The Great Grid Upgrade

Norwich to Tilbury

Design Development Report

AENC-NG-CNS-REP-0005

Figure 5.9 Alignment at Wortham

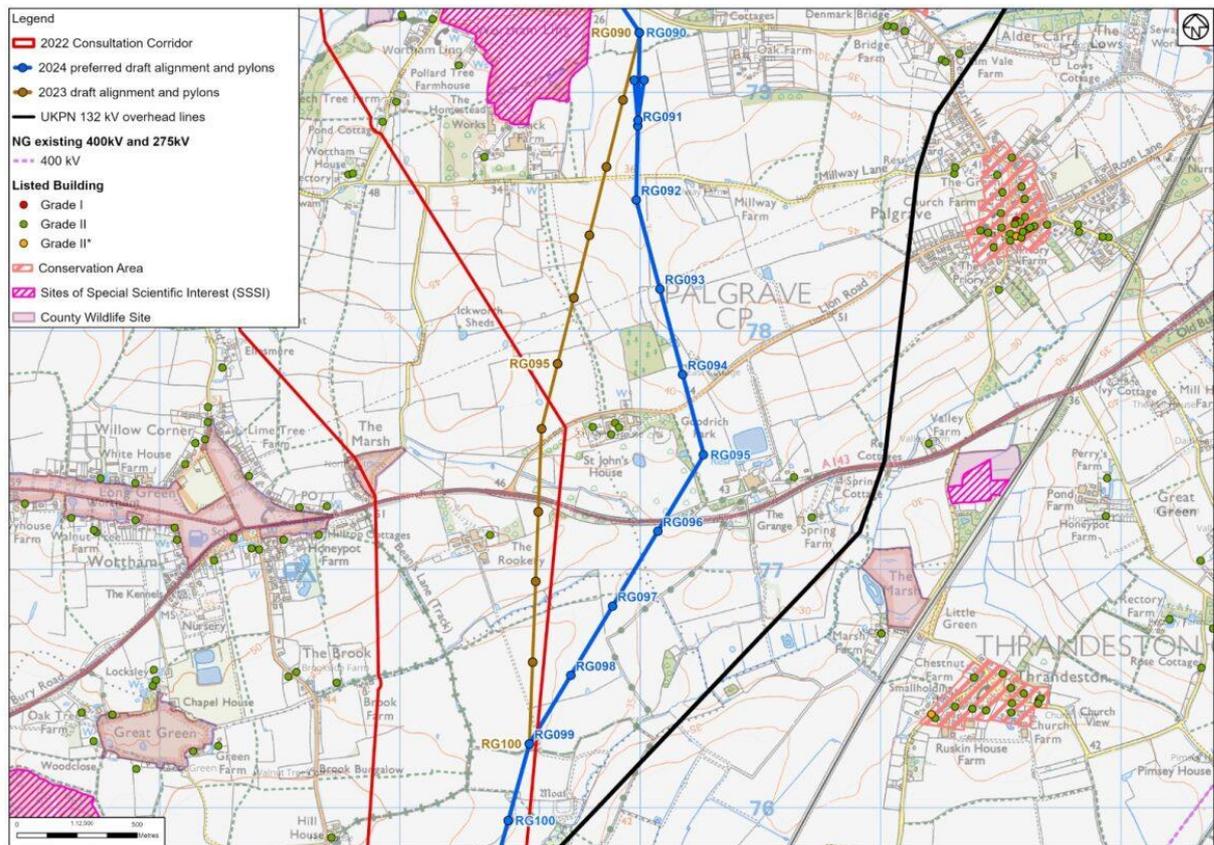
- 5.4.59 Immediately south of the Waveney Valley a further change has been made to the 2023 preferred draft alignment. This is in response to feedback on the potential effects on flight activities at the Brook Airstrip, located to the west of RG099, and feedback about potential interaction with solar farm proposals (see Figure 5.9).

- 5.4.63 The 2024 preferred draft alignment deviates through a different solar farm development than the 2023 preferred draft alignment. This alternative further to the east would transfer effects from one planned solar farm development to another, though subject to final design of the solar farm and the overhead line alignment, the more eastern alignment would reduce the interaction with solar panels from three pylons (on the 2023 preferred draft alignment) to one (2024 preferred draft alignment). This alternative also changes the effects on residential amenity at a number of residential properties. On balance the effects are transferred from Rookery Farm and those near Duck Farm to East Cottage and The Grange. In the case of The Rookery and The Grange, pylons are screened from the properties to some extent, by farm buildings. For those near Duck Farm and East Cottage pylons have been positioned with some limited intervening filtering by trees. On balance with slight reduction in interaction with planned solar development and a transfer of residential effects it was considered that the change to allow continued flight activities was preferred to the closure of the airstrip. Ongoing assessment and feedback will continue to inform decision making around the need for the mitigation of cumulative effects with the 132 kV overhead lattice infrastructure located to the east and connecting to an existing 132 kV substation to the south of Diss operated by the local Distribution Network Operator.

Figure 5.10 Alignment at Mellis

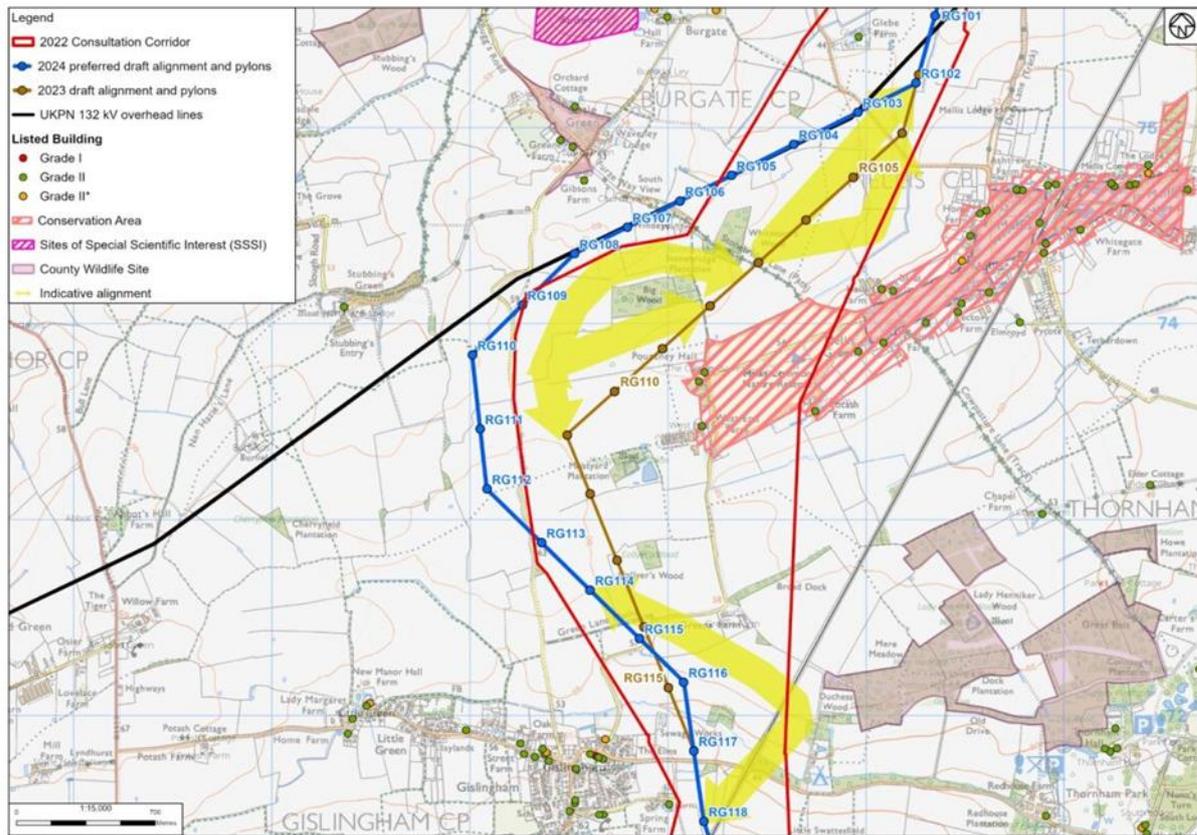
- 5.4.65 In response to feedback localised changes that moved the 2023 preferred draft alignment further from Mellis, albeit remaining on the Mellis side of Big Wood and Stonebridge Plantation, were considered (see Figure 5.10). Such a change can only be achieved by introducing additional angle pylons and moving from an otherwise straight alignment. Whilst noting some slight reduction in effects by slightly increased distance to pylons, it was not possible to meet all requests to position pylons on field boundaries or corners. Overall, it was considered that the benefits would also be substantially offset by the greater visual effects arising from the additional angle pylons required (typically at least 3 additional angles to address the requests). On this basis the suggested changes were less preferred and have therefore not been taken forward.

- 5.4.73 As shown on Figure 5.10 there has been some slight modification to the 2023 preferred draft alignment to the north of the rail crossing. By changing RG117 to a suspension pylon and moving the angle pylon further north, the separation to residential properties at the north-east of the village is increased.

Figure 5.11 Alignment at Wickham Street

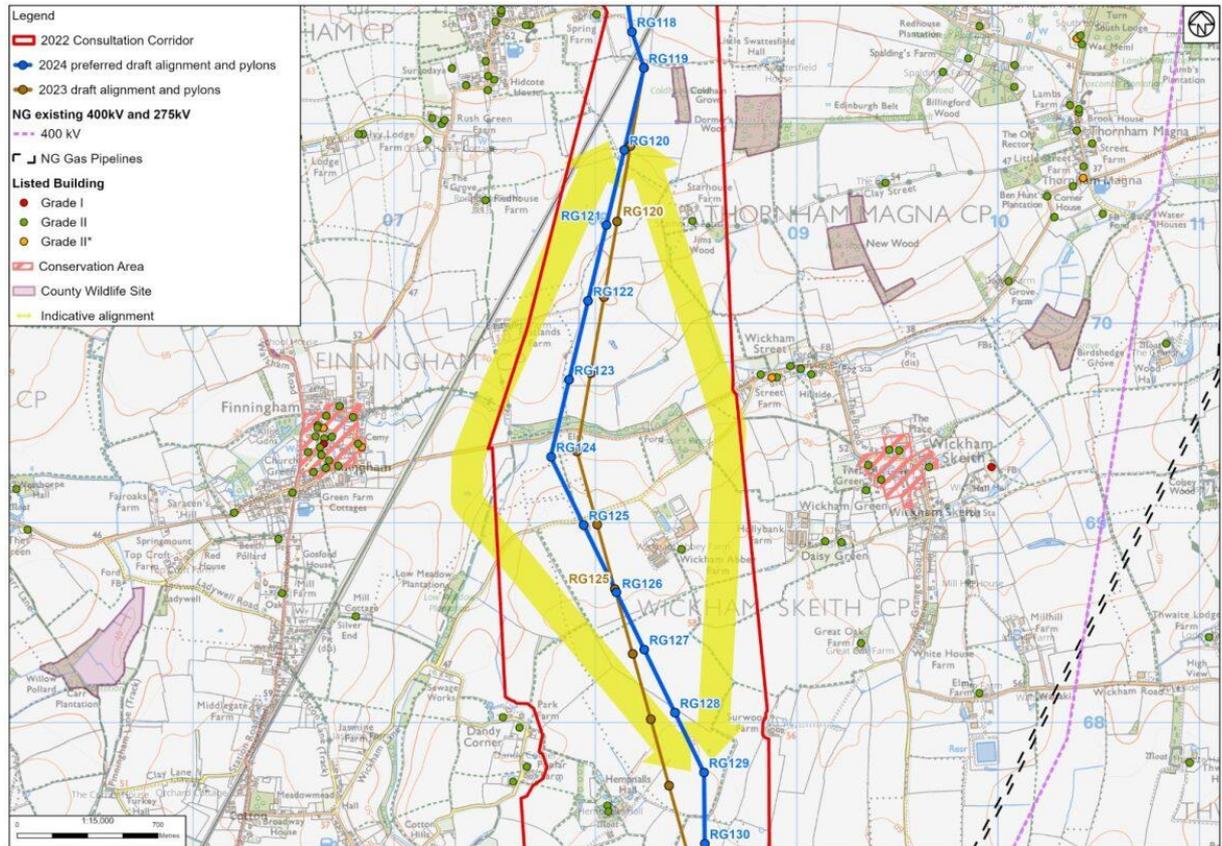
- 5.4.76 Other feedback requested moving RG123 (RG124 in the 2024 preferred draft alignment) further to the west to reduce effects on woodland. Whilst noting the potential for retention of a number of mature trees, this would only be achieved by moving the alignment to the west, closer to Eastlands Farm. Separation to this residential property would be reduced to under 100 m to avoid the area of woodland compared with around 300 m for the 2023 preferred draft alignment). There would also be a potential oversail of the menage area which would need to be mitigated. On balance retaining the 2023 preferred draft alignment at this location was preferred to avoid this transfer of effects to Eastlands Farm.

- 5.4.75 By slightly increasing the angles of direction changes and moving the angle pylon RG123 (which becomes RG124 in the 2024 preferred draft alignment) to the west and moving the angle at RG130 (2023 preferred draft alignment) to the north to RG129 (2024 preferred draft alignment) landowner preferences can at least partly be met (RG122 and RG123 on the 2023 preferred draft alignment would move to field boundaries) (see Figure 5.11). Separation to Hempnalls Hall can also be increased without materially increasing effects on receptors to which the alignment has moved marginally closer. These minor adjustments to the west of Wickham Skeith have been included in the 2024 preferred draft alignment.

Figure 5.14 Alignment at Offton

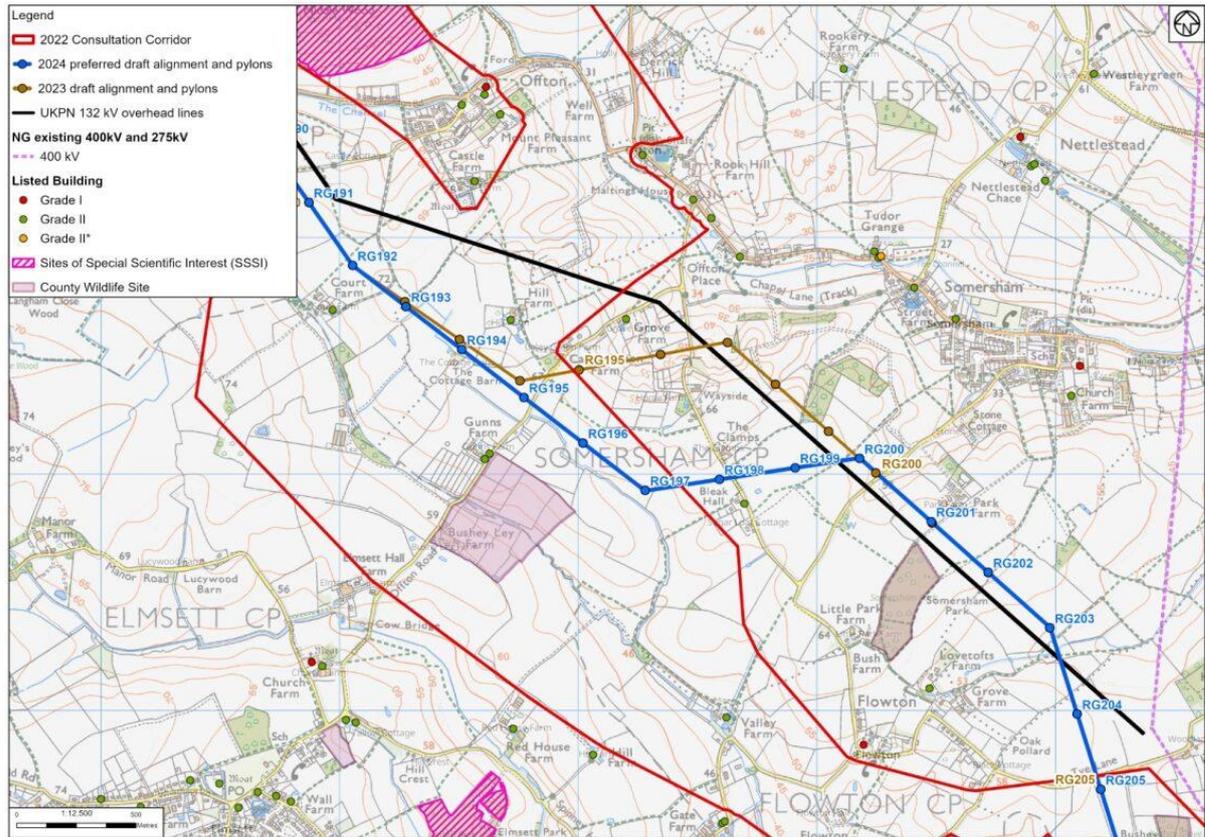
5.4.91 Feedback proposed a change to the 2023 preferred draft alignment which oversail an equestrian school business (oversailed at RG196 on the 2023 preferred draft alignment) and also has residential amenity effects on views from around four properties (Grove Farm and others on Elmsett Road and Wayside to the south). Responding to this feedback, as shown on Figure 5.14, an alternative was considered that comprised continuing the alignment to the south-east of RG195 (previously RG194 in 2023) before turning east to rejoin the route of the 2023 preferred draft alignment at RG200 which itself would be repositioned to the northwest of its 2023 location. This alternative would stay on slightly higher ground than the 2023 preferred draft alignment, which partially drops onto lower ground, however this slightly reduced consistency with the Holford Rule achieves the avoidance of the oversail of the equestrian school business. Additionally, the alternative reduces overall effects on residential amenity albeit some transfer of residential amenity effects occurs to two properties (The Clamps and Bleak Hall) even with pylons positioned outside main views.

5.4.92 Feedback restating a preference for alternative alignments within or to the west of the 2022 Consultation Corridor between Offton and Bramford Substation was also reviewed. In the absence of additional factors or new material considerations it is considered that these alternatives are less preferred. Alignments to the south of Flowton or closer to Elmsett transfer effects to other receptors and increase effects on Grade I listed churches (Church of St Mary and Church of St Peter respectively). It is also notable these alternatives alignments do not directly require the replacement of the existing 132 kV connection with underground cable meaning that any such change (to install underground cable in the place of the 132 kV overhead line) would be determined by the outcome of a cumulative assessment of effects of the various overhead lines which may not in themselves be of sufficient magnitude to lead to a change.

Figure 5.15 Alignment at Chattisham

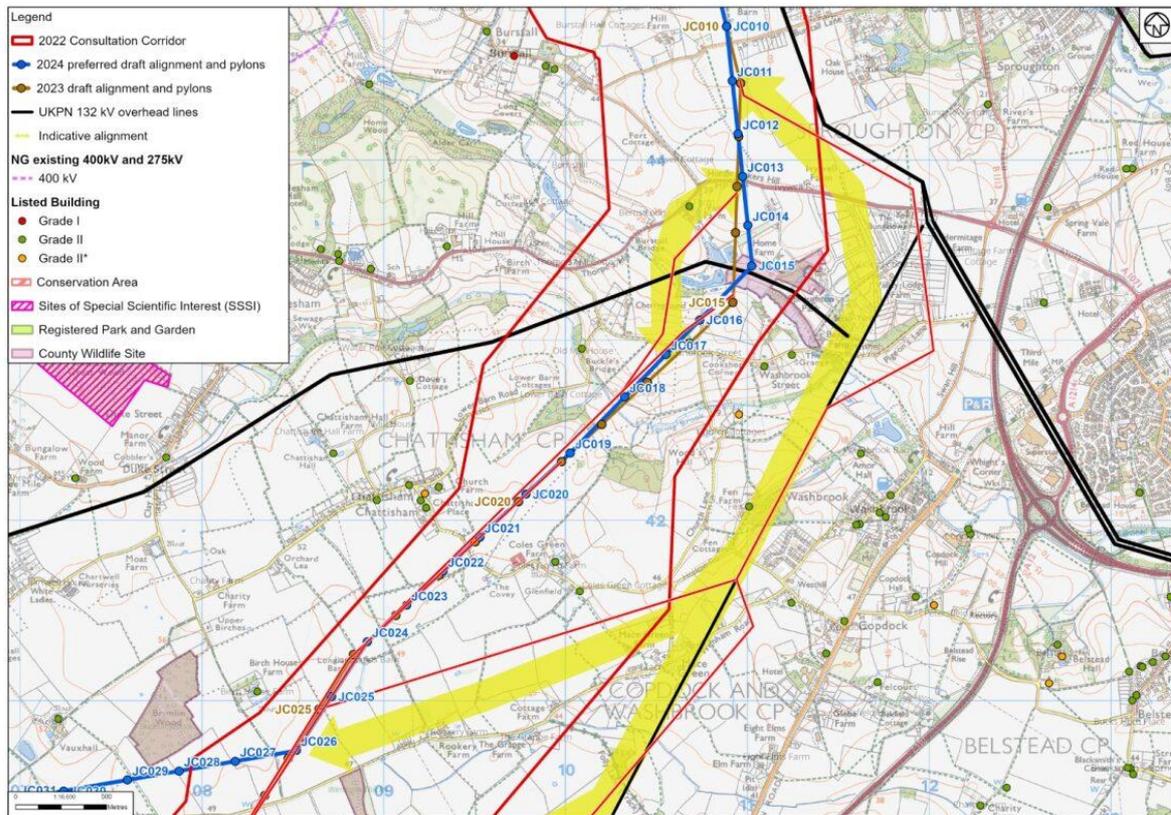
- 5.4.95 As shown in Figure 5.15, feedback proposed the adoption of the alignment of the 132 kV overhead line from Bramford Substation through to the EACN substation. This has been considered as it may have offered an opportunity to reduce the magnitude of change. The existing 132 kV overhead line however passes between and very close to residential properties (in the order of 30 m from centreline) where the greater scale of the 400 kV infrastructure means that insufficient space is available to achieve acceptable separation from residential properties. This occurs at a number of locations, for example at Mace Green, where there are residential properties to each side at approximately 30 m from the overhead line centreline to each side and at White Horse Road in East Bergholt.

5.4.97 Overall, alternatives following the existing 132 kV overhead line were not preferred and the 2023 alignment has been taken forward as the 2024 preferred draft alignment.

Figure 5.16 Alignment at Hintlesham Fisheries

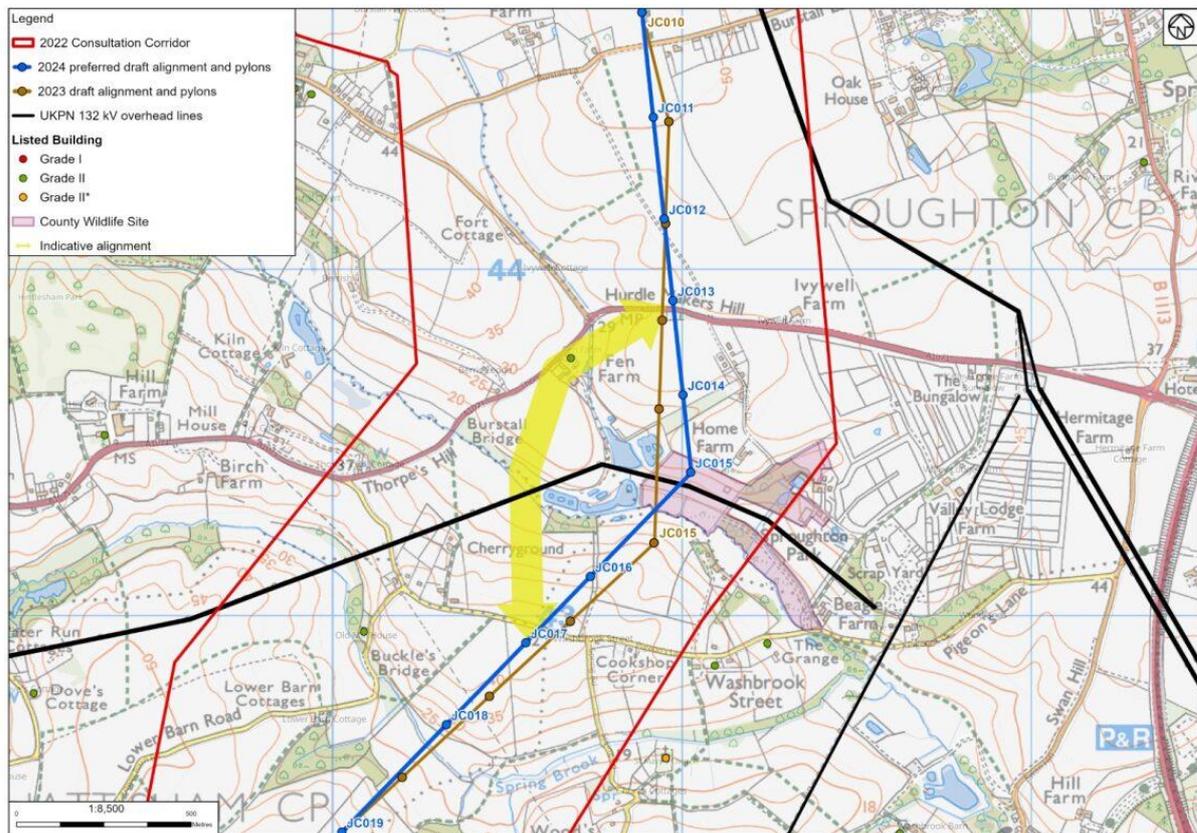
5.4.99 Immediately south of Bramford (see Figure 5.16), minor adjustments to the 2023 preferred draft alignment and pylon positions are proposed between JC010 to JC020 (pylon numbers are unchanged) to respond to feedback and likely restrictions to existing land use activities.

- 5.4.101 On balance it is proposed to take forward this alternative on the basis that whilst residential amenity effects and ecological effects are potentially increased there are opportunities for additional mitigation and the revised alignment would allow the fishery business to continue to operate.
- 5.4.102 An alternative passing to the west of the Hintlesham Fishing lakes (between the lakes and Fen Farm) was also considered. Whilst this would move the alignment further from the residential properties on Valley Road it would transfer effects to other residential properties and require the use of multiple angle pylons, increasing local visual effects. This was less preferred than the alternative described above.

Figure 5.17 CSE siting and alignment north of the AONB

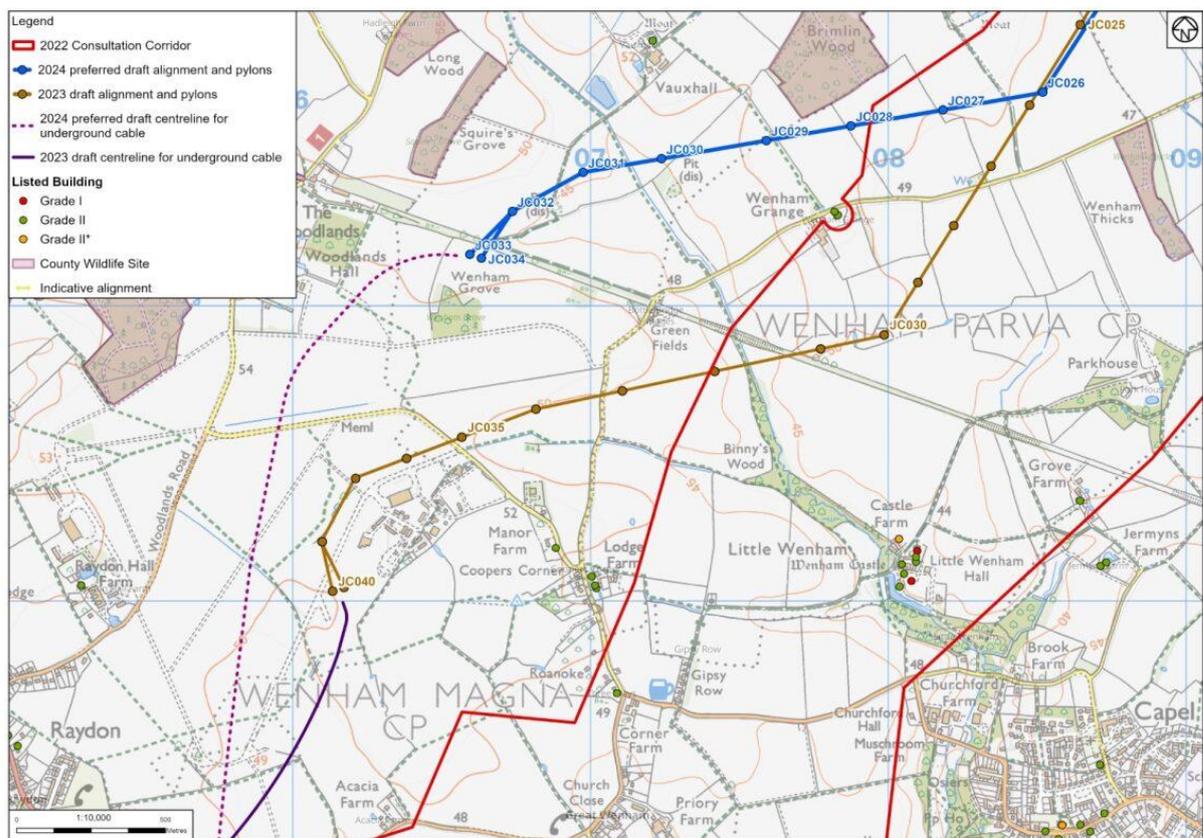
- 5.4.106 Alternative locations for the CSE compound were considered guided by the Horlock Rules. These included a site between Wenham Grove and the disused railway as well as a site to the north of the disused railway (around JC032 on the 2024 preferred draft alignment). Siting north of Wenham Grange using Brimlin Wood as screening / backclothing (around JC029 to JC028 on the 2024 preferred draft alignment) was also considered (see Figure 5.17).

Figure 5.18 Alignment at Ardleigh

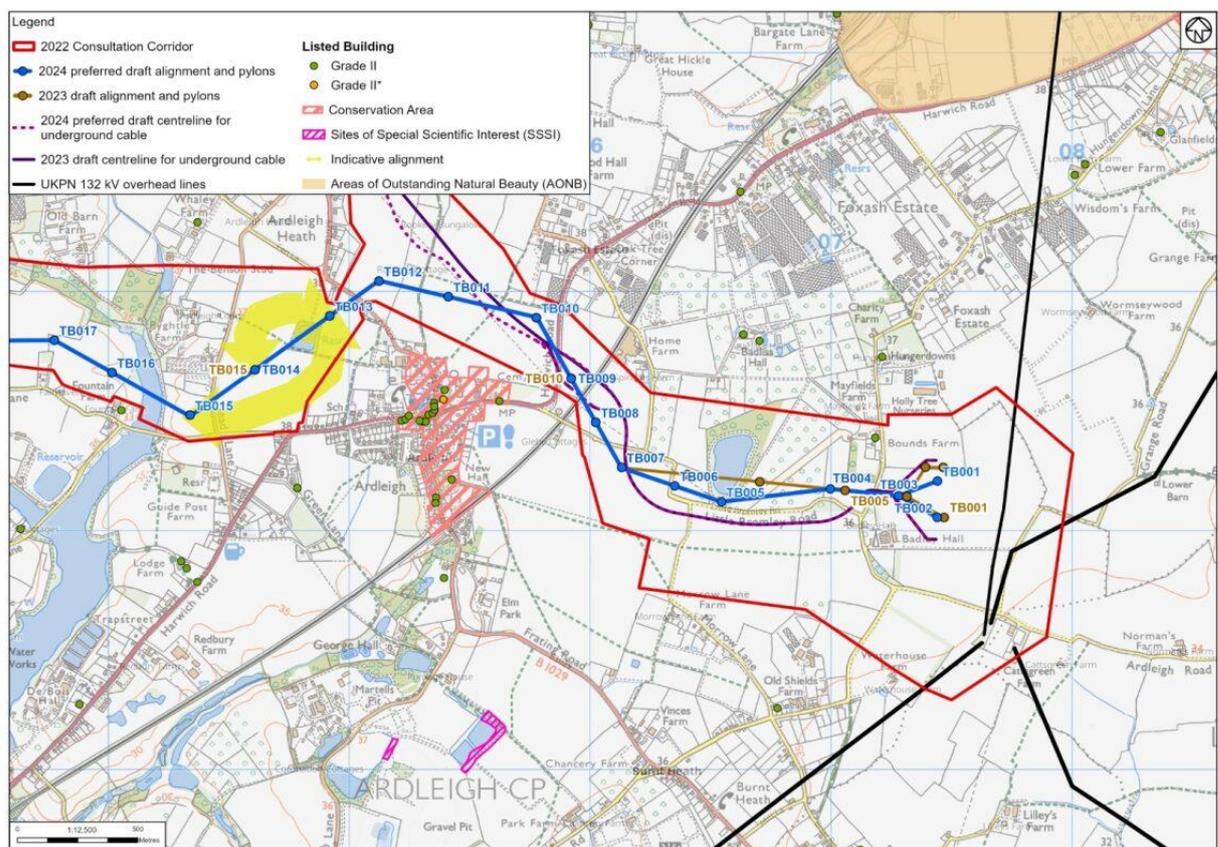
- 5.4.123 Heading west from the EACN substation, minor adjustments to the 2023 preferred draft alignment are proposed with the removal of pylon TB03 (as identified in 2023) as a result of modifications to the line entry arrangements at the EACN substation (see Figure 5.18).

5.4.124 Through landowner engagement the potential for effects on a fishing lake due to oversail by the overhead line between 2023 preferred draft alignment pylons TB006 and TB007 has been identified. Where such oversail occurs, fishing activity would need to be restricted for safety reasons and here the 2023 preferred draft alignment would potentially have affected around half of the lake. The alternative is to realign the overhead line between TB004 and TB007 (identified as TB005 to TB008 in the 2023 preferred draft alignment) introducing additional angle pylons to reduce the oversail, with pylons also positioned to reduce effects on a fruit farm. This change introduces two additional angle pylons with consequent additional visual effects (and is less consistent with the Holford Rules). The closest residential properties either benefit from some visual screening (e.g. Bounds Farm) or are at around 500 m or greater distance. On balance it is considered preferable to take forward the realignment to reduce the impact on the fishing lake on the basis of the separation and / or vegetation filtering between the angle pylons and the closest residential properties.
